# Access Compliance Report

## Public Rights-of-Way

### (Pedestrian Signals)

Intersection ID: N/A	Main Street:	Cross Street: N/A	Location: N/A
ADA ID: 364DBC78F98A	Signal Type: One Push Button-Non APS	Overall Compliance: No	Severity Score: BTN 1: N/A BTN 2: N/A No BTN: N/A
Codes/Mitigation Info/Possible Solution		Field Measurements/Component Compliance

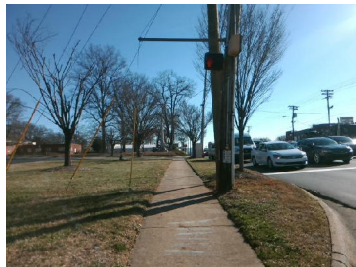
PROW/ADA: TMUTCD 4e.08, R404.7.3, R404.7.2

Possible Solutions: Replace Signal Push Button With APS Button on New Post. Remove & Relocate Sign.
